## Narrabri Coal Project

# Preferred Project Report

June 2007

**Figure 2.1 (preferred)** presents the preferred Project Site Layout while **Figure 2.5 (preferred)** presents the preferred Pit Top Area layout.

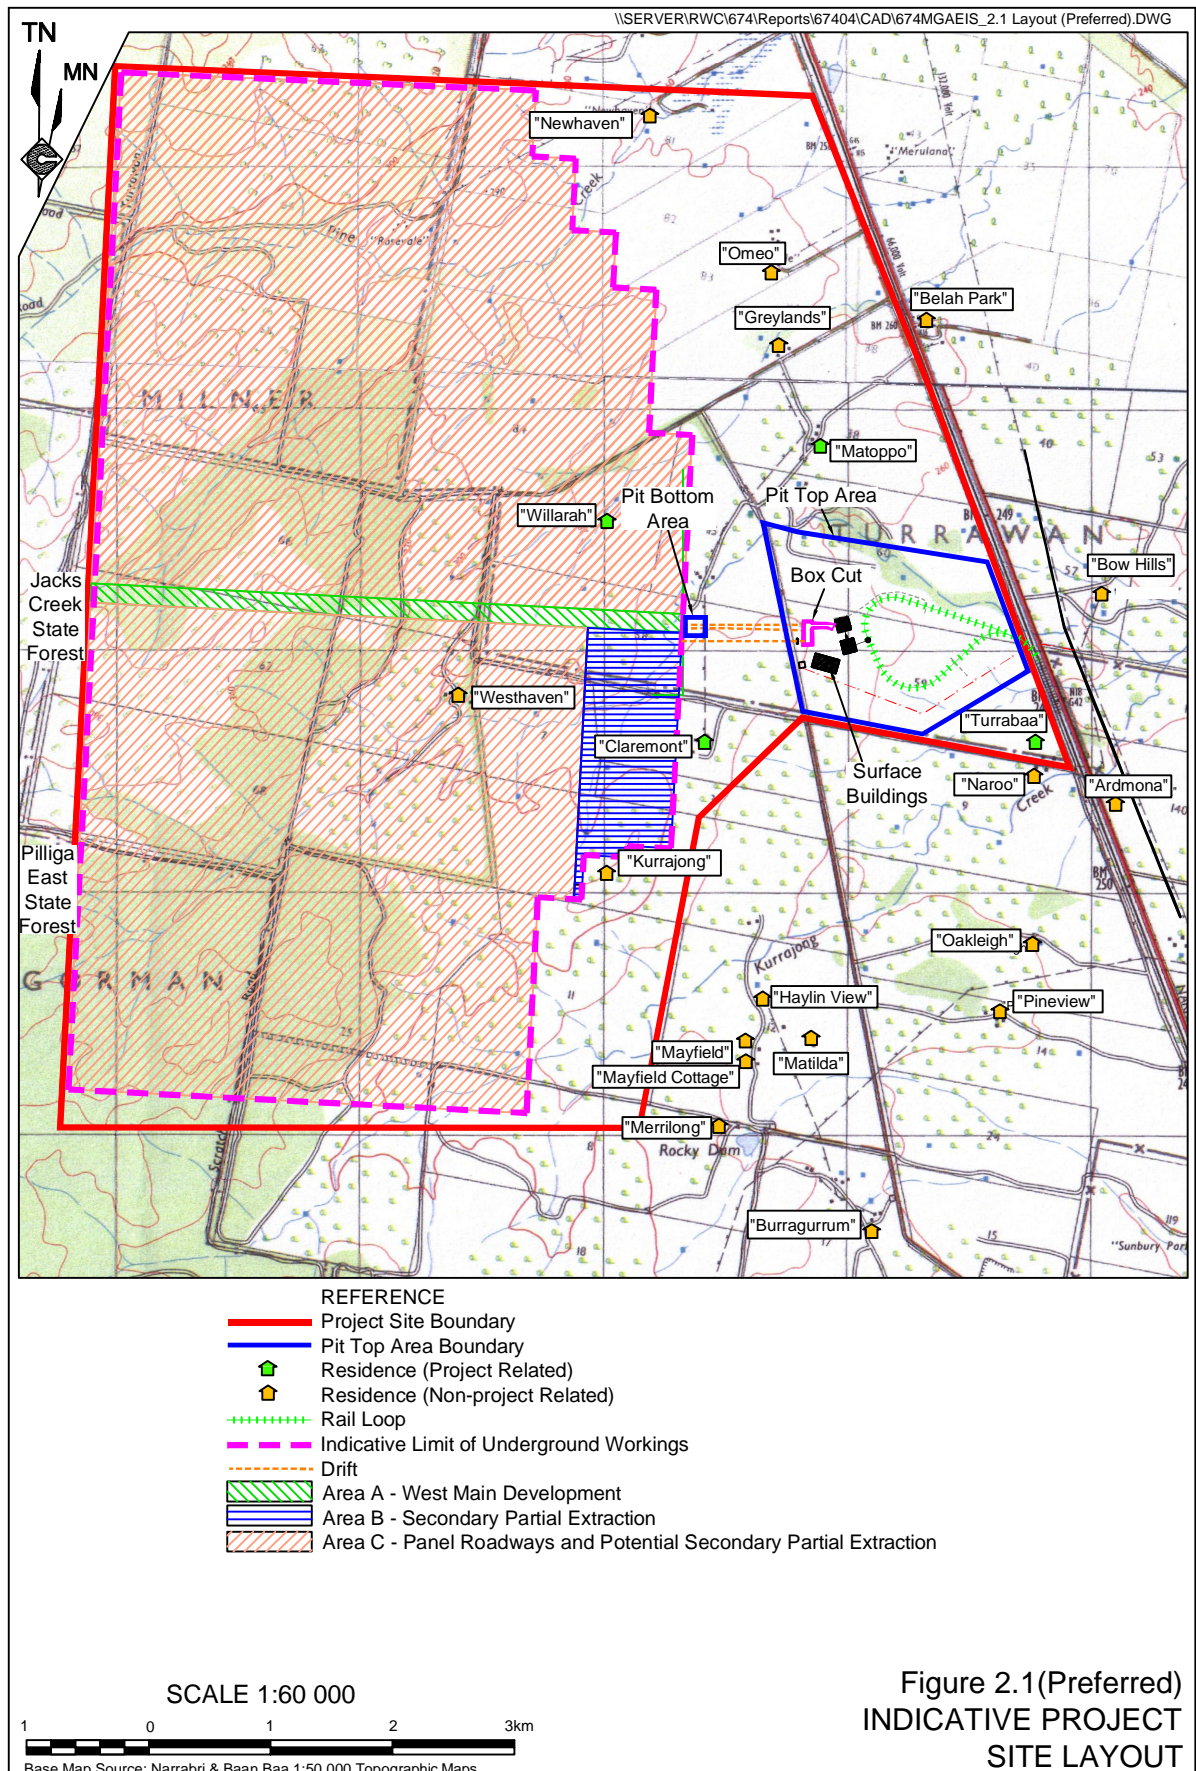
The DECC submission to the Department of Planning, following a review of the *Environmental Assessment*, recommended disturbance to native vegetation within the Ventilation Shaft Area for the installation and management of a ventilation fan be avoided.

Based on the assessment of these, the Proponent now proposes to ventilate the underground workings via a third “ventilation drift”, the entry to which would from the floor of the box cut. In order to accommodate the third drift, the box cut excavation would be extended to the south, requiring an additional area of disturbance of 0.6ha. The additional overburden (approximately 176 500m<sup>3</sup>) would be used to construct a secondary containment bund within the rail loop and downstream of the evaporation / waste water (“brine”) storage ponds.

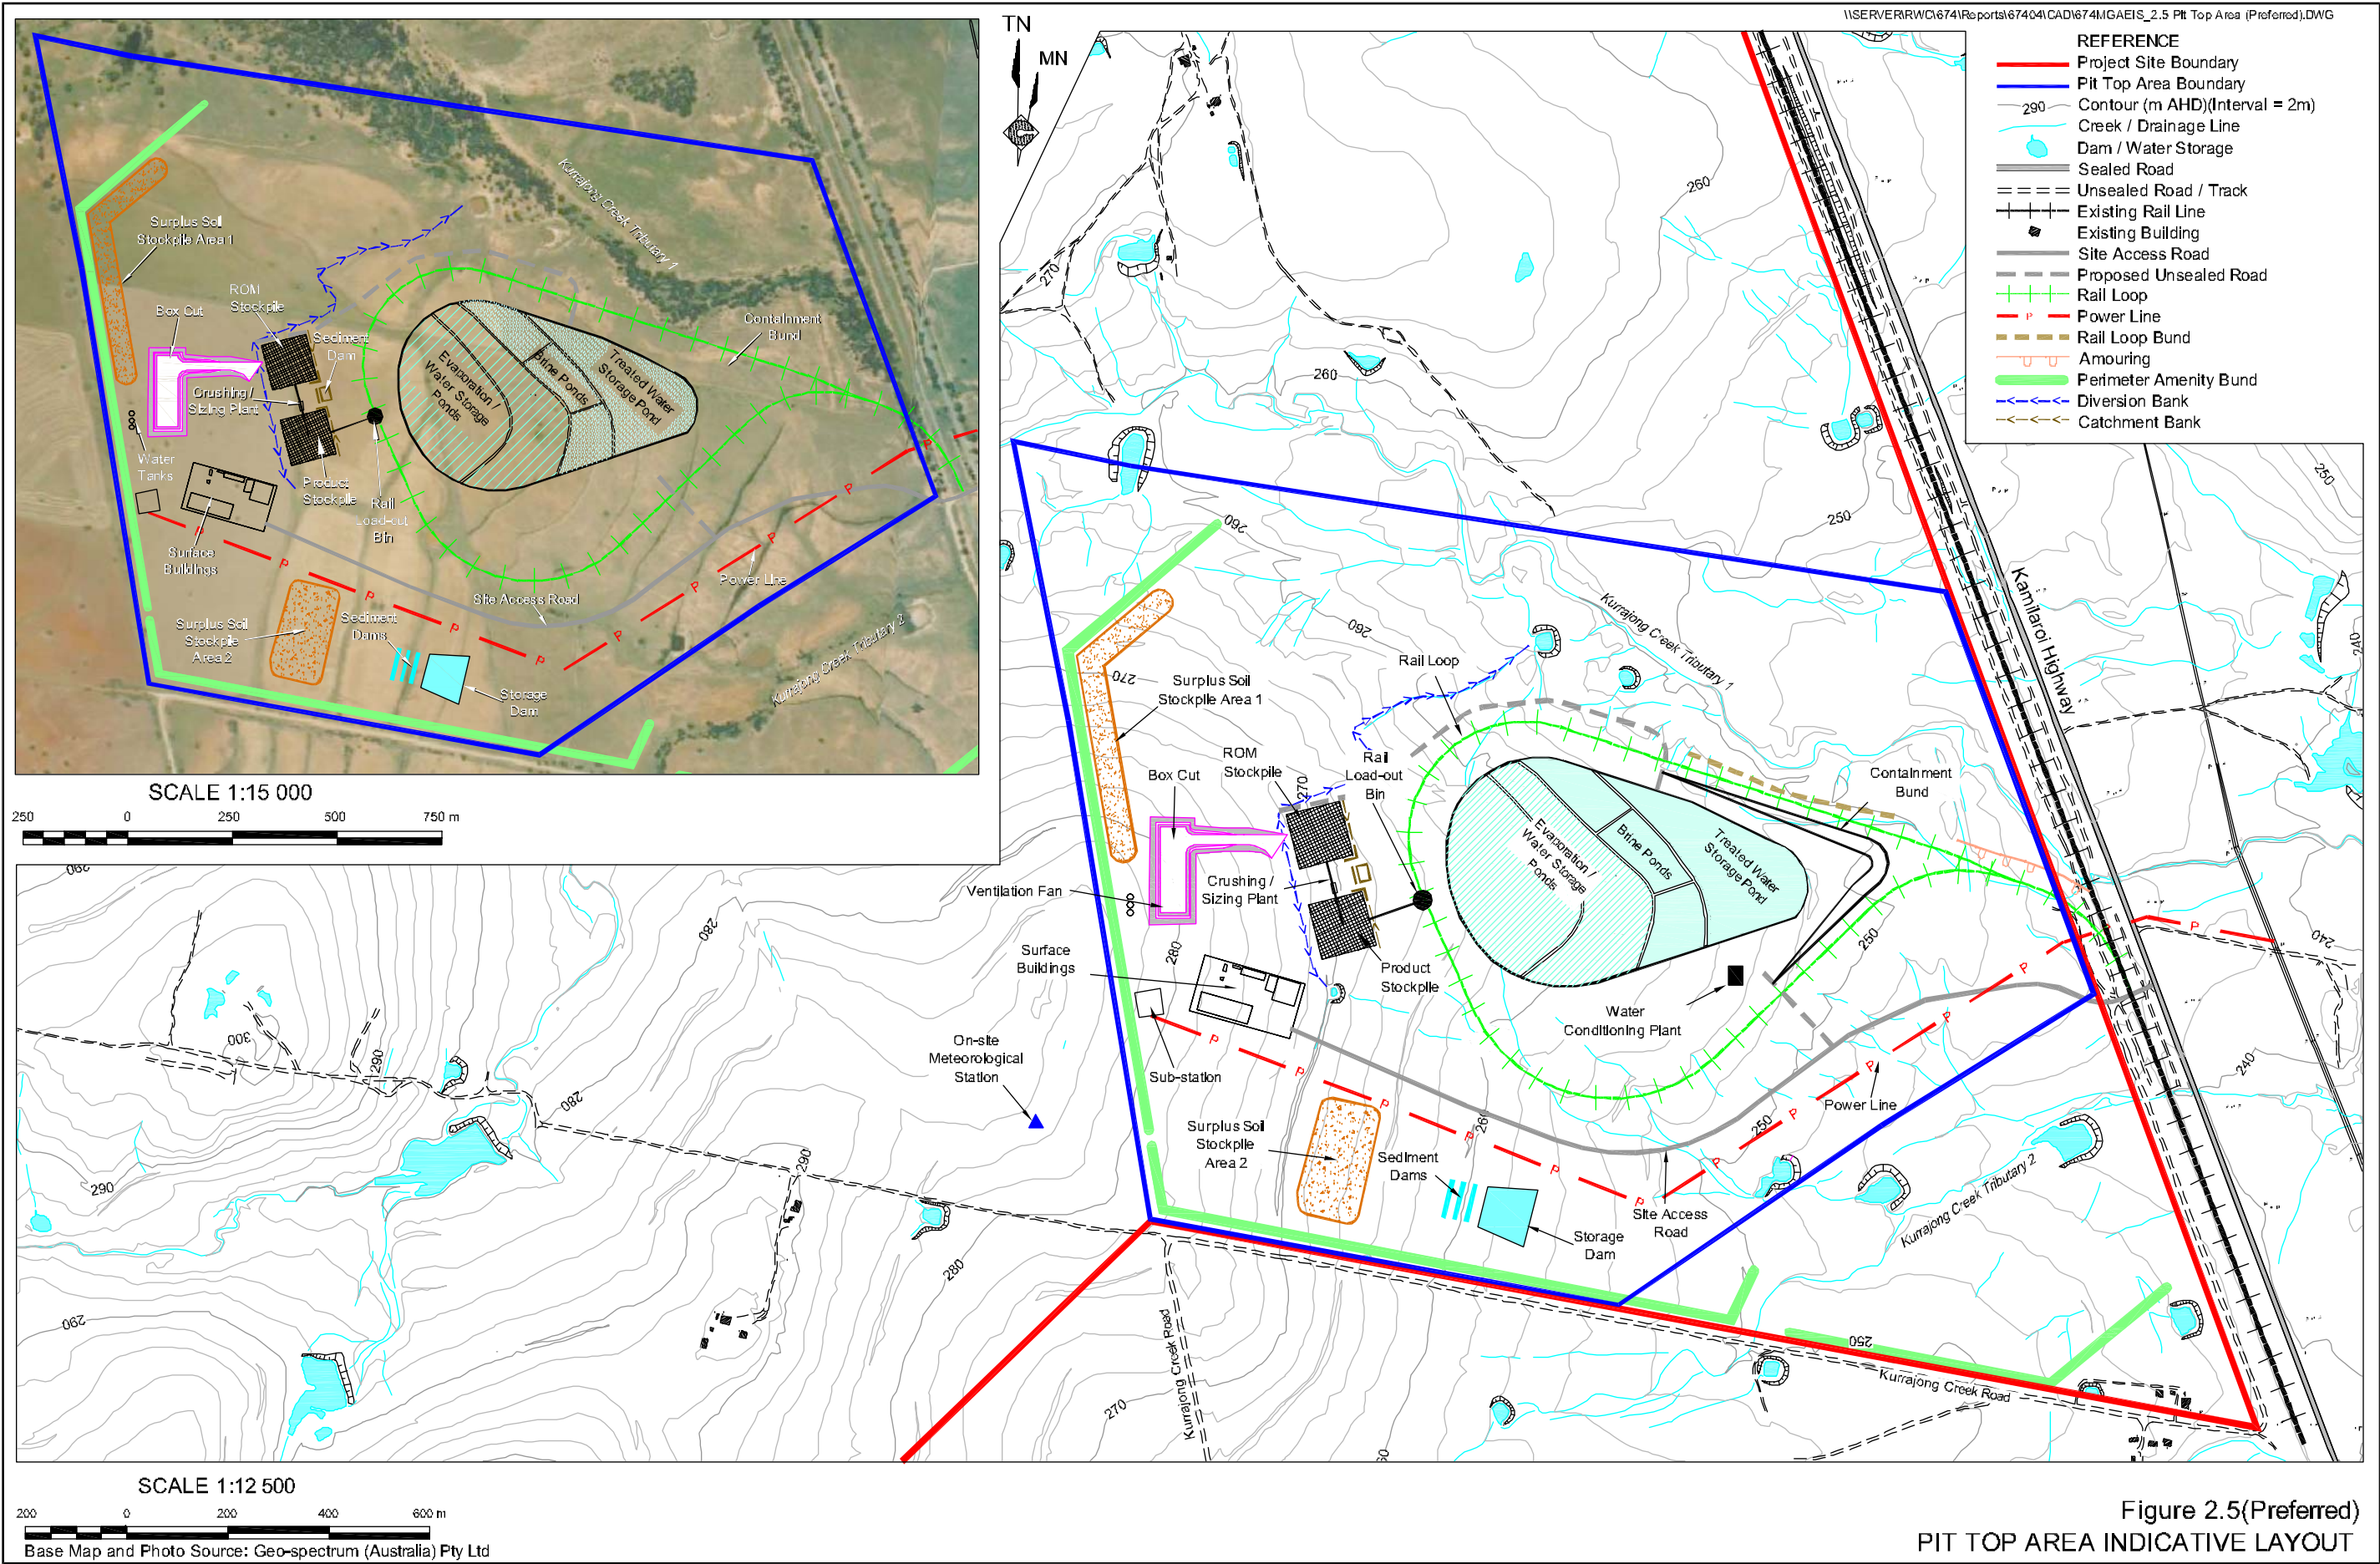
Evaporation Pond C would be converted to a series of storage cells of roughly 80m x 170m x 5m dimensions to store and evaporate the reverse osmosis water conditioning plant waste water ("brine") (see **Figure 2.5 (preferred)**). The floor and walls of the "brine ponds" would preferentially be lined with at least 900mm of clay material with a permeability not exceeding  $1 \times 10^{-9}$  m/s. Preliminary saturated permeability tests of clay material available from the Pit Top Area suggest this level of impermeability could be achieved, however, further testing will be undertaken following the receipt of project approval to confirm sufficient clay material is available. In the event either the material is found to be too permeable, or there is insufficient volume of the material, one or more of the ponds used to store saline water will be lined using an FML with a permeability not exceeding  $1 \times 10^{-14}$  m/day. A layer (up to 500mm) of fine clay (no rocks or gravel) would be prepared below the liner to minimise the potential for puncturing and a similar depth layer placed over the liner to reduce possible degradation by UV radiation and allow for excavation of accumulated salt without the risk of puncturing the liner.

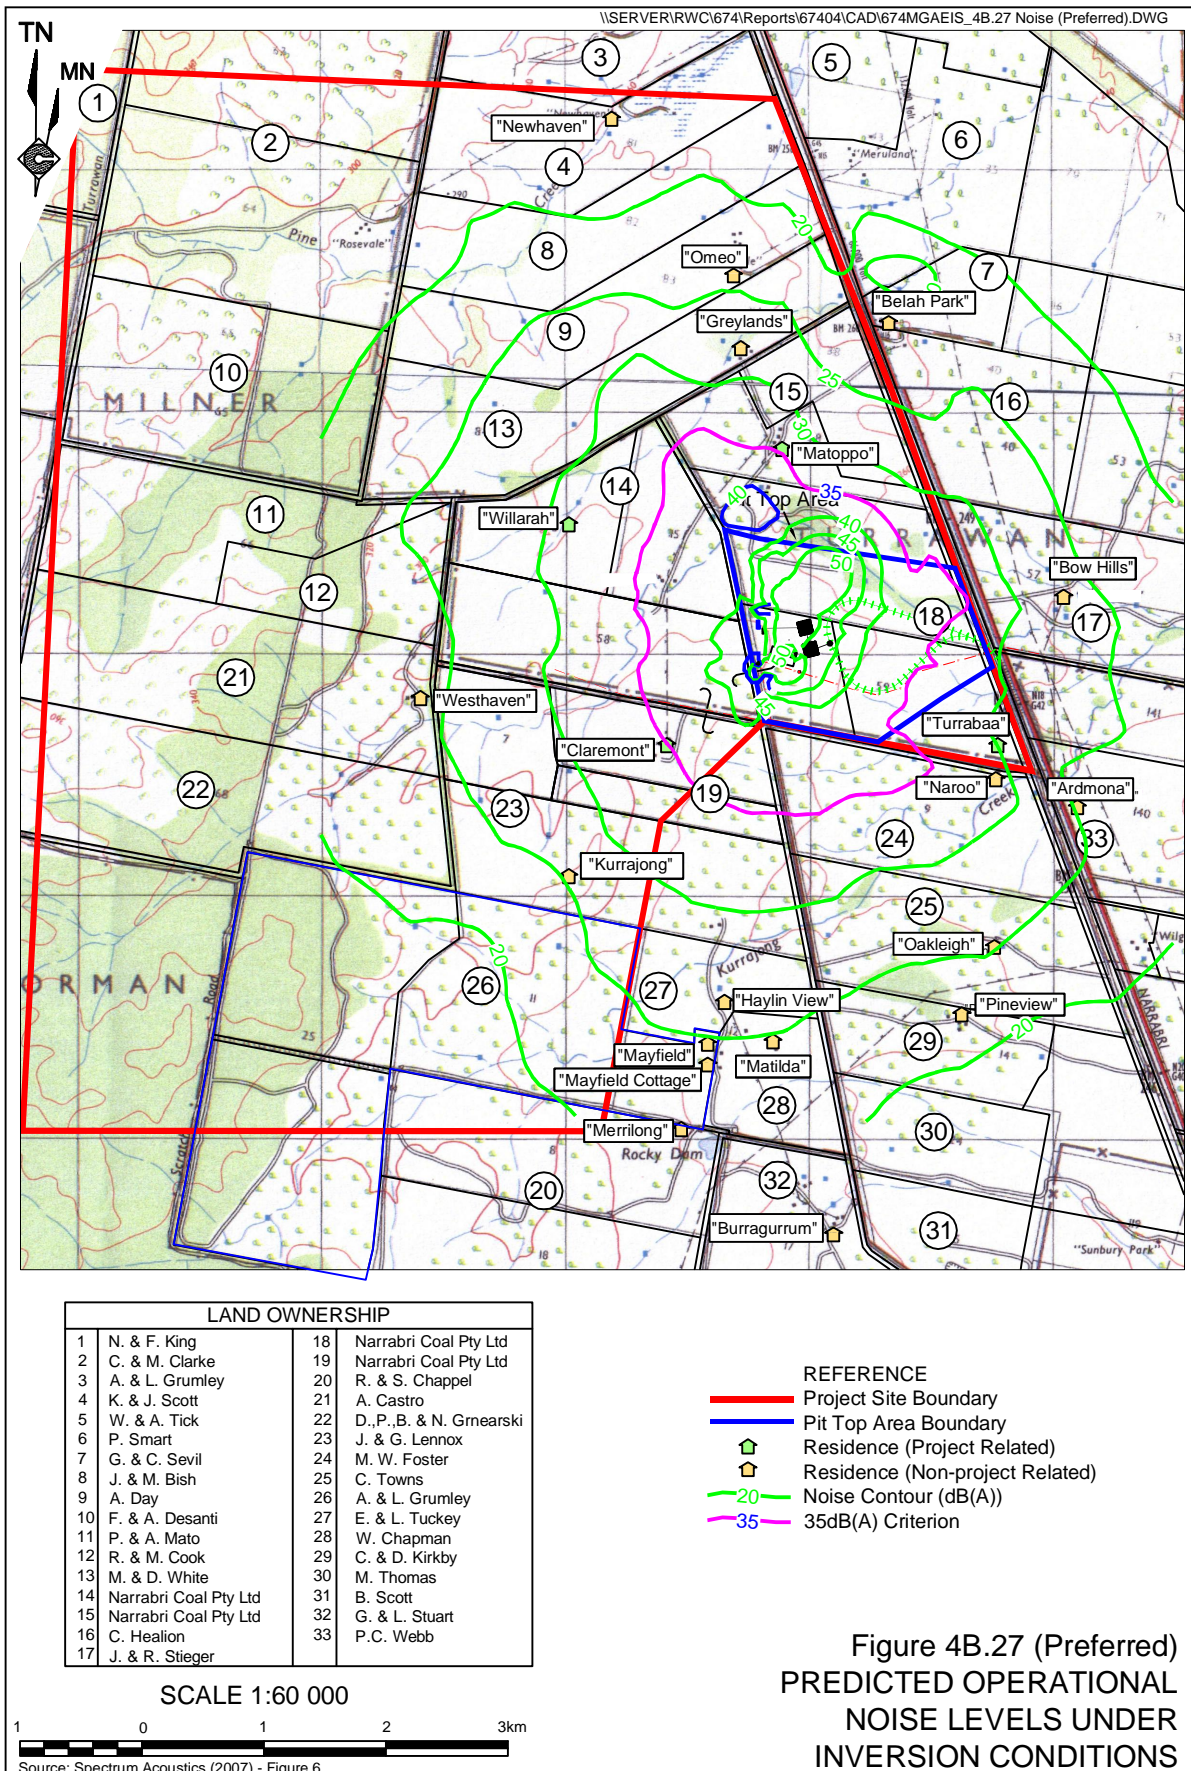
By comparing **Figure 4B.27** (preferred) to Figure 6 of Spectrum (2007) (also **Figure 4B.27** of the *Environmental Assessment*), it can be illustrated that there may be a minor increase in noise levels received at residences to the north, south and east (although still well below noise criteria of 35dB(A)). The non-project related residences that may experience slightly elevated noise levels include:

Residences to the west of the Pit Top Area, however, would experience reduced noise levels (of at least 5dB(A)). Residences which would receive substantial benefit include:
